# Groundwater Application Review Summary Form

Application # G- 19404

# PUBLIC INTEREST REVIEW FOR GROUNDWATER APPLICATIONS

**A. GENERAL INFORMATION:** Applicant's Name: Richard Hari, Hari Farm and Nursery County: Marion

### Water-Level Measurements in Nearby Wells

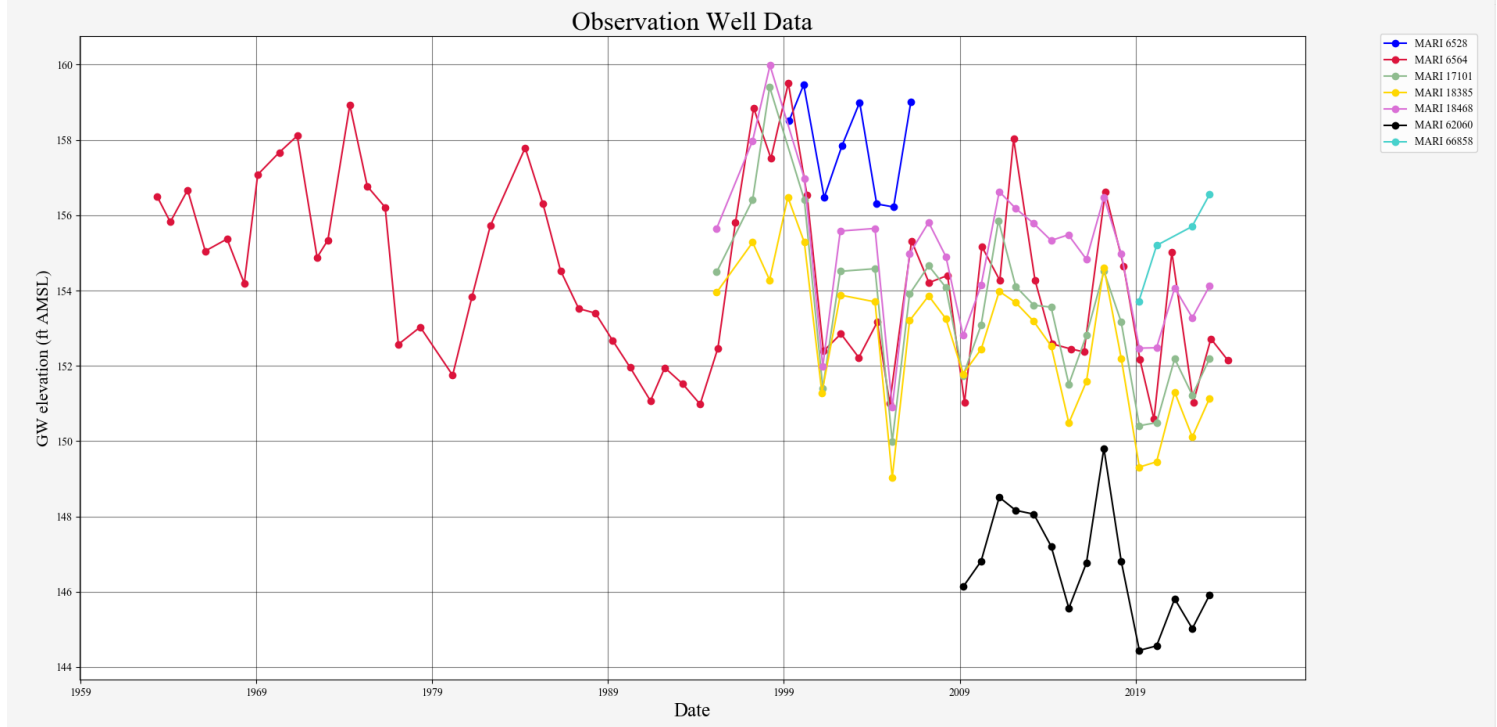
**Basis for aquifer hydraulic connection evaluation:** Groundwater SWL in nearby wells range from 146 to 166 ft amsl and the reported regional water table elevation is between 140 and 160 ft amsl. (Gannett and Caldwell, 1998; Woodward et al., 1998). The streambed of SW 1 (Little Pudding River) is between 136 and 146 ft amsl within a mile of the POA. The WBZ of the POA (MARI 6514) is 81 to 160 ft bls [45 to 124 ft amsl]. The elevation of SW 1 (Little Pudding River) is lower than the groundwater SWL, indicating the local groundwater is likely discharging to this SW. The streambeds of SW 2 (Fruitland Creek) and SW 3 (West Fork Little Pudding River) are coincident with the local groundwater elevation. The surface water sources have not incised below the elevation of the WBZs of the confined alluvial aquifer. Hydraulic connection to SW 1, SW 2, and SW 3 is likely but anticipated to be inefficient due to the low vertical permeability of the overlying fine-grained sediments.

### Thisis Interference Analysis

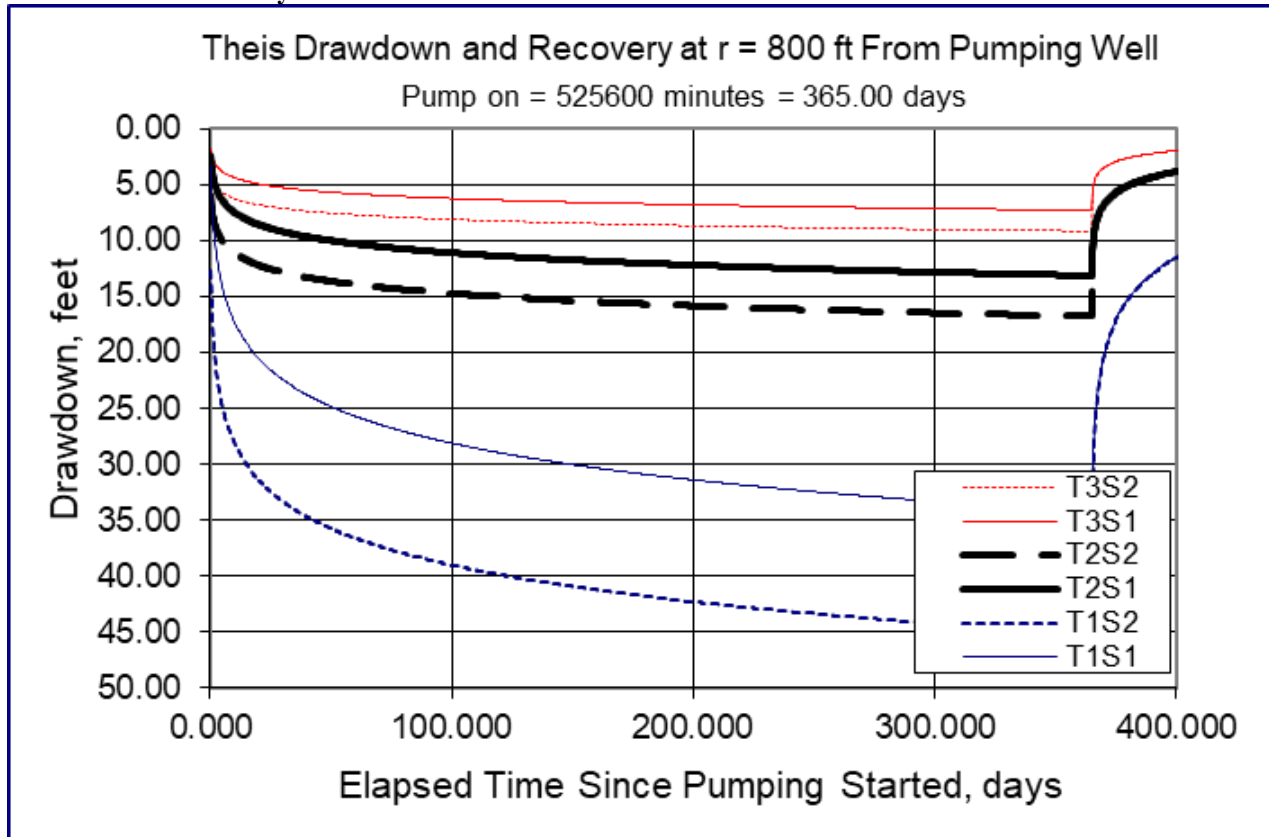
The nearest groundwater user to the POA is MARI 6511 (POA for Permit G-11940 with priority date 6/24/1992 and Certificate 46795 with priority date 12/2/1974), with an estimated location 800 ft southeast of the POA, at an elevation of 197 ft amsl. MARI 6511 is completed to a depth of 205 ft bls (-8 ft amsl). It is likely the proposed use would cause some degree of well-to-well interference with MARI 6511. To assess the degree of drawdown, a Theis drawdown analysis was conducted for the proposed use (see [Theis Drawdown Analysis](#)). Results indicate that the proposed use is not likely to cause well-to-well interference with MARI 6511 that exceeds the threshold under the standard condition for alluvial aquifers in the Willamette Basin.

Radial distance from pumping well ( $r$ )=800 ft [estimated radial distance to nearest user, MARI 6511]

**Pumping Rate ( $Q$ )= 0.74 cfs (~333.85 gpm)\***

Aquifer Transmissivity ( $T_1$ )= 8,078 gpd/ft (1,080 ft<sup>2</sup>/day), ( $T_2$ )= 24,235 gpd/ft (3,240 ft<sup>2</sup>/day), ( $T_3$ )= 47,124 gpd/ft (6,300 ft<sup>2</sup>/day)

Storativity ( $s_1$ ) = 0.0001, ( $s_2$ ) = 0.001 [Conlon et al 2005, Table 1 and 2 values for MSU]

Total pumping time=365 days [year-round Nursery Use]

\*The full pumping rate could not be utilized continuously for the entire 365-day period of use without exceeding the 538.5 ac-ft maximum allowed duty. For the maximum allowed duty of 538.5 ac-ft, continuous pumping would occur for 365 days at a rate of 0.744 cfs (~333.85 gpm).

Based on this analysis of the available data and under the assumptions previously identified, groundwater for the proposed use will likely be available in the amounts requested and within capacity of the resource. The conditions specified in B1(d)(i) and B2(c) are recommended to protect senior users and the groundwater resource.
